APPLICATION NO.	FILING DATE	FIRST NAMED INVENTOR	ATTORNEY DOCKET NO.	CONFIRMATION NO.
10/624,152	07/21/2003	Richard A. Fuelling		5651

Office Action Summary

This is the first Office Action for application number 10/624,152 Modular Accessory Holder, filed on 7/21/03. Claims 1-3 are pending.

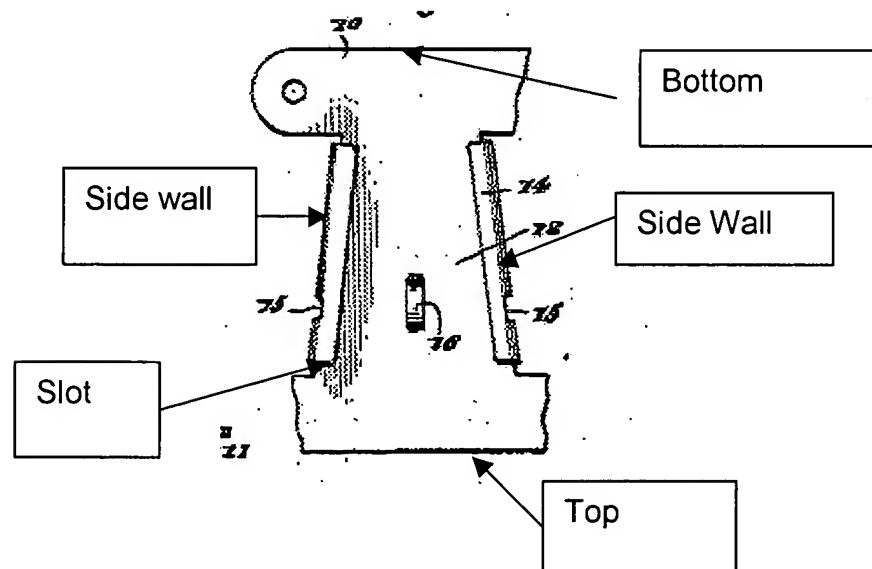
Claims 1 and 2 are rejected under 35 U.S.C. 102(b) as being anticipated by United States Patent No. 2174140 to Schofield.

The patent to Schofield discloses a device having a receiver (10) fixedly attached to a fixed point, wherein the receiver has a top surface (See Drawing Below), and an open front, a slot opening in the top surface and descending downward therefrom having an upper portion and a lower portion, wherein the slot is bounded by a back wall (12), a front wall (14), and first and second side walls (See Drawing) which taper toward each other so that the upper portion is wider than the lower portion of the slot.

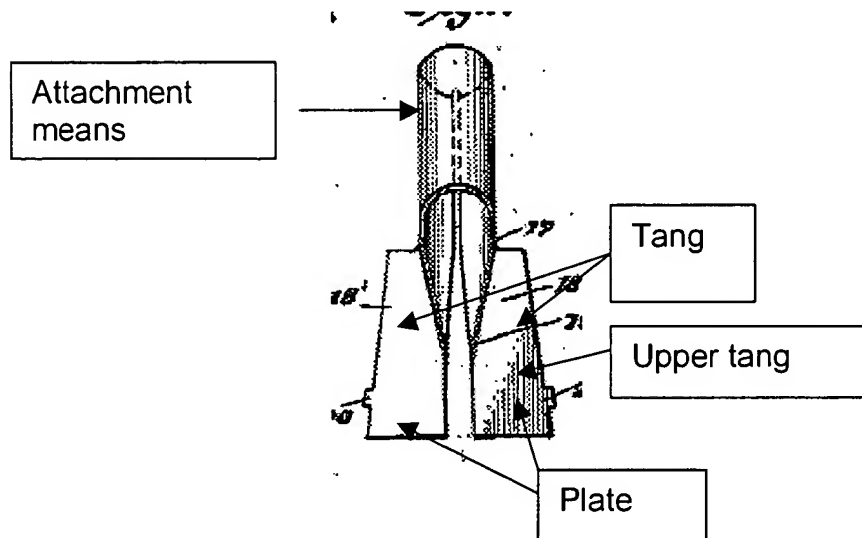
Shofield also discloses a modular mount (17, 18', 19, 20) including an attachment means (See Drawing Below), a plate (See Drawing), a tang (See Drawing) having a back wall, a front wall, a first and second side wall, the tang descending from the plate first and second steps (20) proximate to a junction between the tang and the plate, wherein the first and second side walls of the tang taper toward each other so that the upper portion of the tang is wider than the lower portion.
